# UNITED STATES PATENT AND TRADEMARK OFFICE

APPLICATION NO.	FILING DATE	FIRST NAMED INVENTOR	ATTORNEY DOCKET NO.	CONFIRMATION NO.
10/598,498	08/31/2006	Toyohiro Sakai	SW24-P07062US	6460
33356 7590 09/10/2007 SoCAL IP LAW GROUP LLP 310 N. WESTLAKE BLVD. STE 120 WESTLAKE VILLAGE, CA 91362			EXAMINER KANG, EDMUND C	
			ART UNIT 2885	PAPER NUMBER
			MAIL DATE 09/10/2007	DELIVERY MODE PAPER

<b>Office Action Summary</b>	<b>Application No.</b>	<b>Applicant(s)</b>	
	10/598,498	SAKAI ET AL.	
	<b>Examiner</b>	<b>Art Unit</b>	
	Edmund C. Kang	2885

## **DETAILED ACTION**

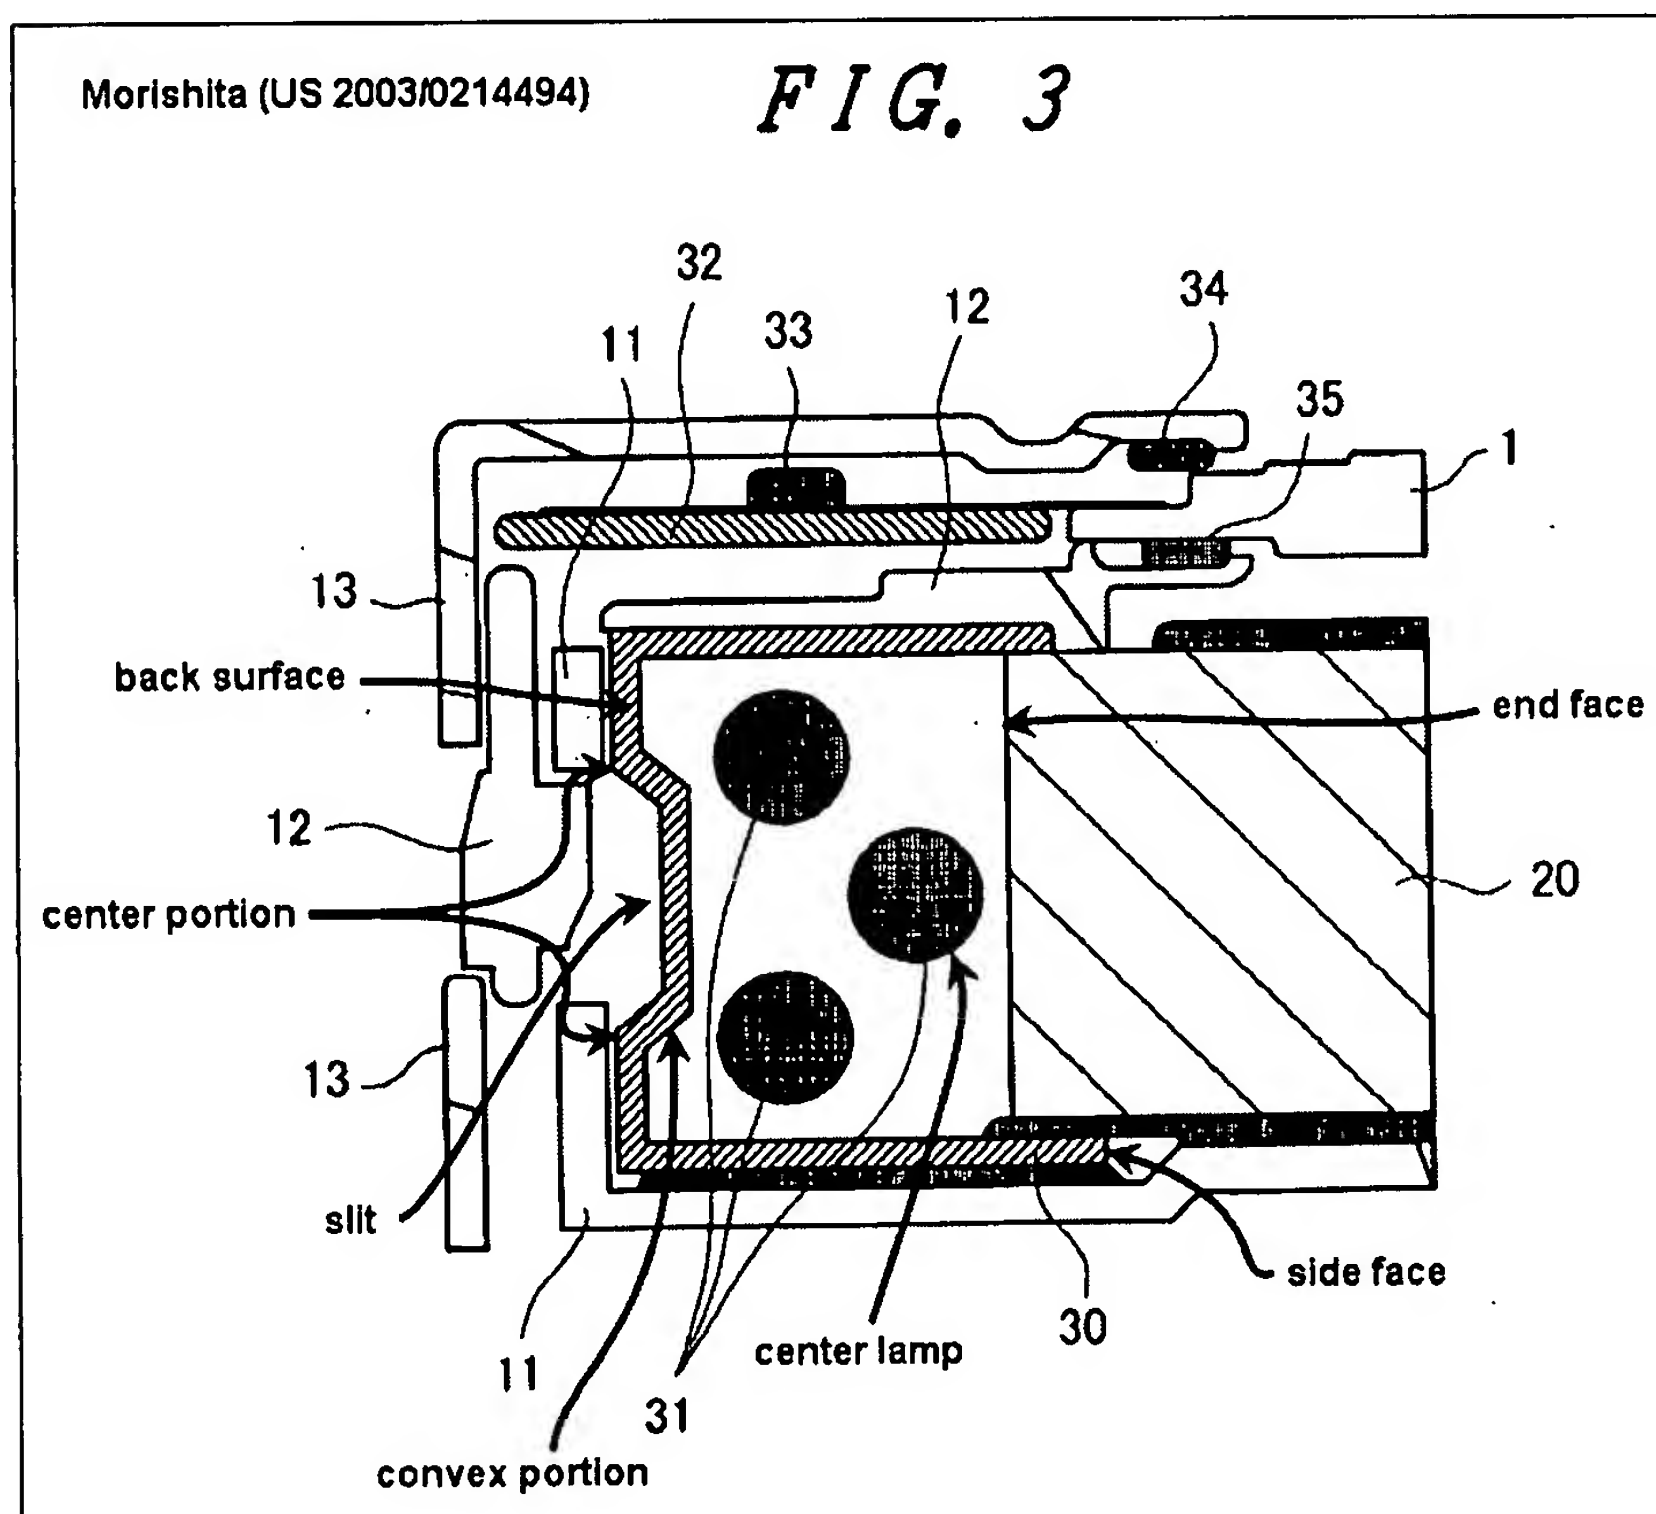
a light guide plate (Fig. 3, **20**), three or more linear lamps (Fig. 3, **31**) arranged along an end face (see annotated Fig. 3 below) of the light guide plate, and a lamp reflector (Fig. 3, **30**) arranged so as to surround said linear lamps for reflecting light from the linear lamps to a light guide plate side (see Fig. 3),

said linear lamps being, when viewed from an end face side of the light guide plate, arranged so that all the linear lamps are directly visible without being shielded by another linear lamp (see Fig. 3), and among said linear lamps, a center linear lamp (annotated Fig. 3) in a thickness direction of the light guide plate end face being arranged closer to the light guide plate side than other linear lamps (see Fig. 3), and

said lamp reflector comprising a back surface (annotated Fig. 3) which faces the plurality of linear lamps and a side face (annotated Fig. 3) for supporting the back surface against the light guide plate, said back surface having a convex portion

(annotated Fig. 3) projecting inward at a center portion (annotated Fig. 3) along a longitudinal direction of the reflector.

The teachings of Morishita in view of Yasuhiro have been discussed above. Morishita further discloses a slit (annotated Fig. 3; **[0067]**, "...recess provided on the reflector plate 30..." ) formed along a longitudinal direction of the lamp reflector back surface.

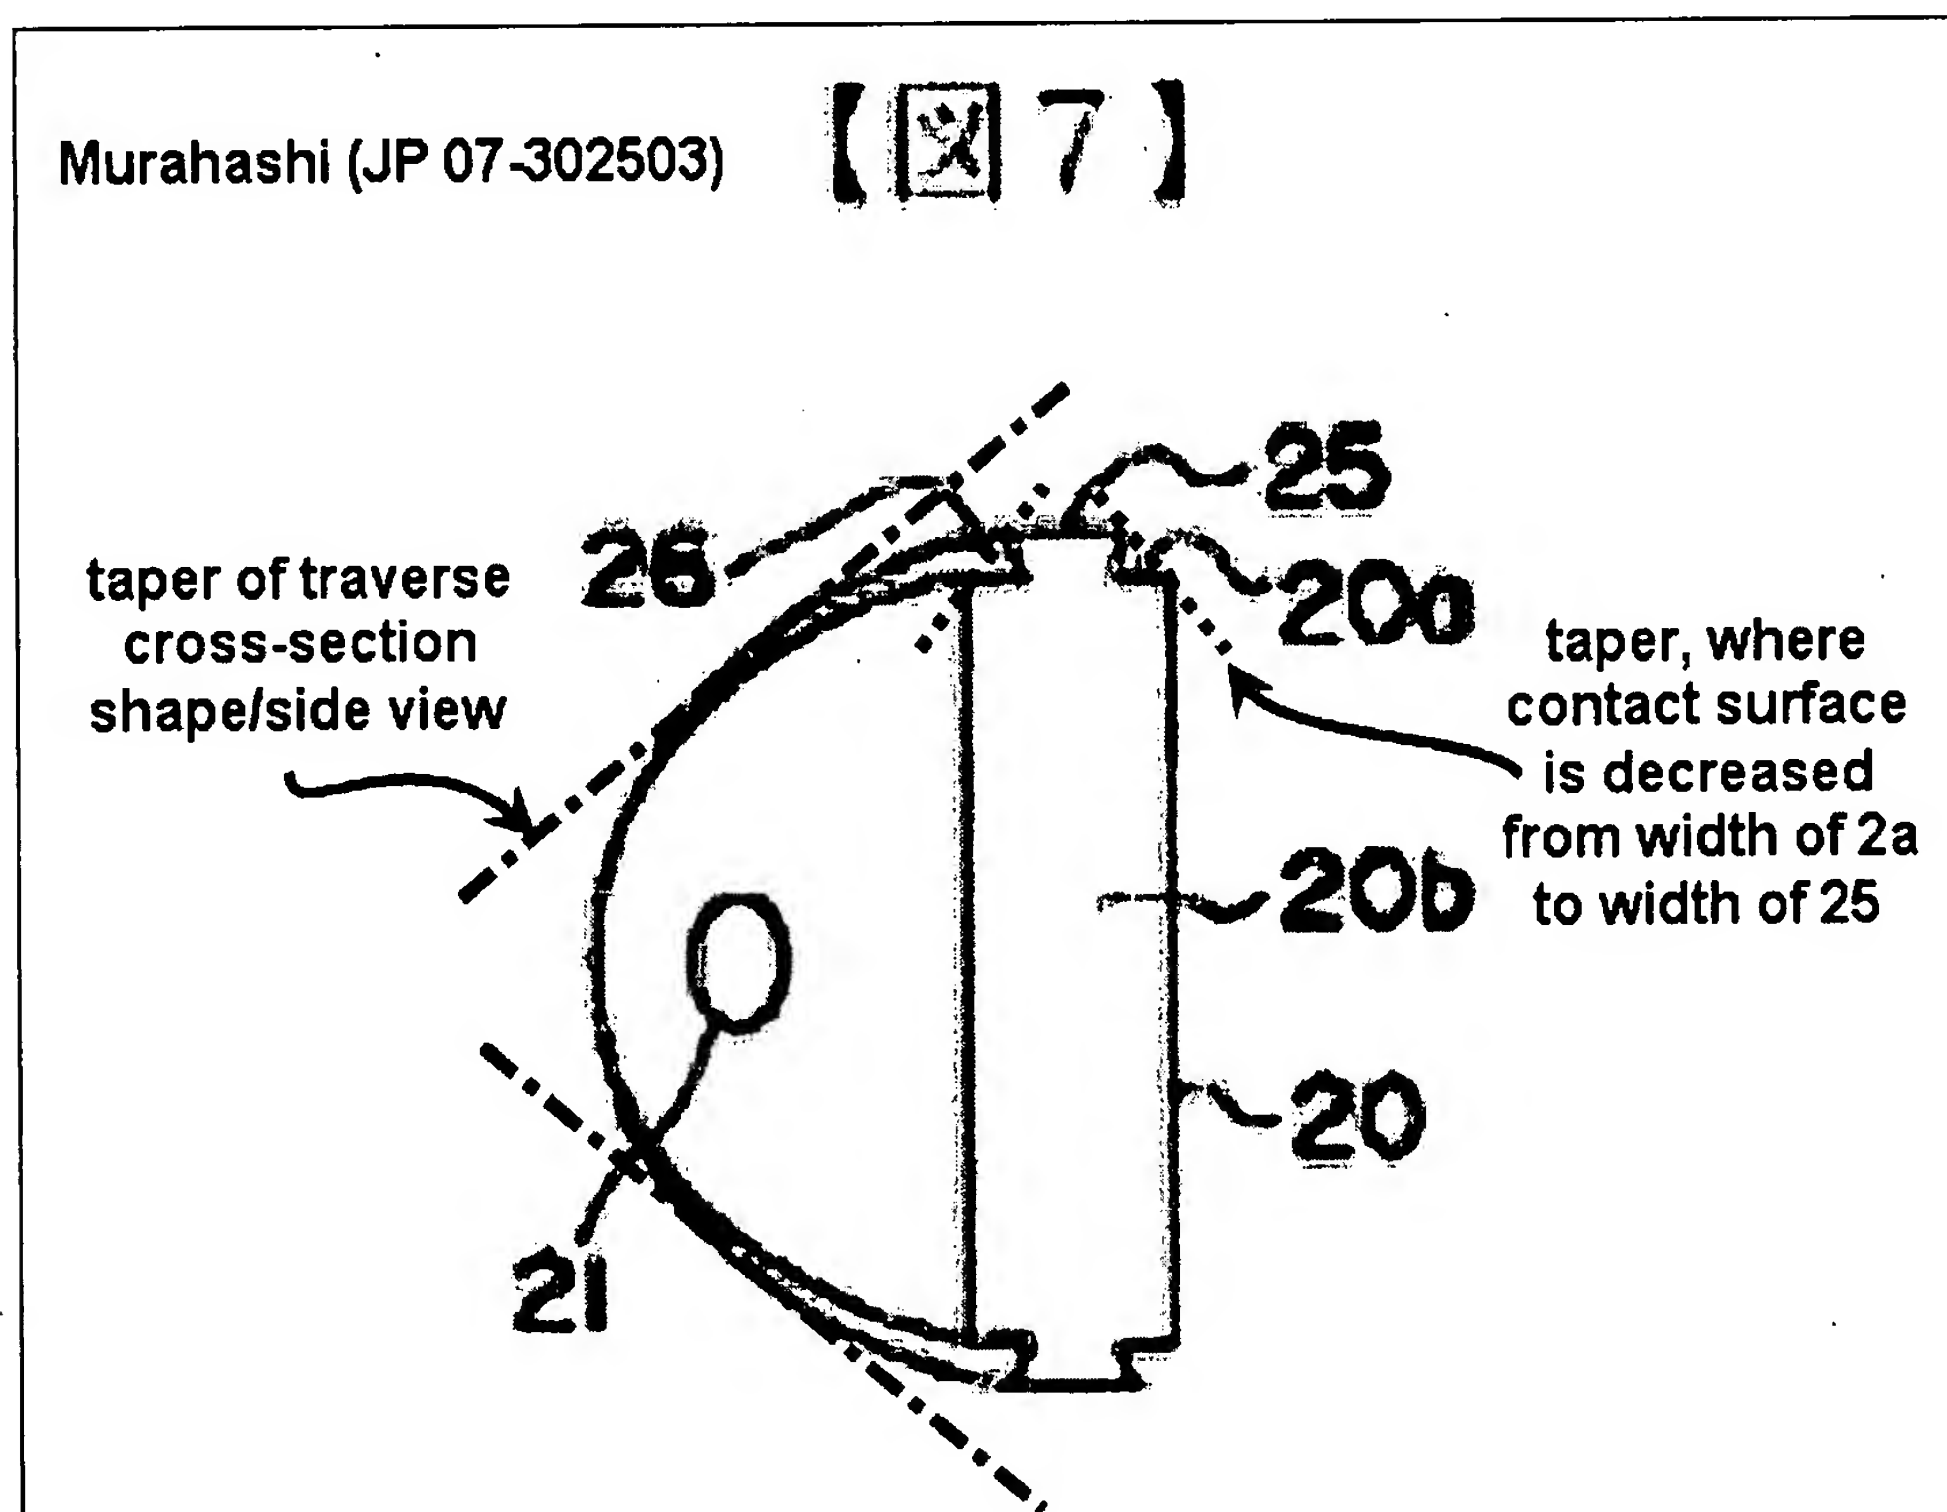
However, Murahashi further teaches in another embodiment that the insulating spacer is provided with a taper (see annotated Fig. 7 below), whose contact surface area of at least one contact section (Fig. 7, **25**) with said linear lamps, lamp reflector, or light guide plate is made to decrease, and whose traverse cross-section shape is formed in a tapered manner (annotated Fig. 7); and wherein the taper of the insulating spacer is formed from a plurality of planes (Fig. 7, **25, 26, 20a**).

It would have been obvious to one having ordinary skill in the art at the time the invention was made to further modify the backlight of Morishita in view of Yasuhiro and Murahashi, by tapering the portion of the insulating spacer that contacts the lamp reflector using a plurality of planes, and also forming a traverse cross-section shape in a tapered manner, in order to decrease the width of the edge of the insulating spacer, such that contact of the spacer with the reflector is minimized, thereby further reducing

The use of planes, rather than a smooth curved surface to create the taper is beneficial, since a straight edge has less potential to slip or rotate against a surface that it
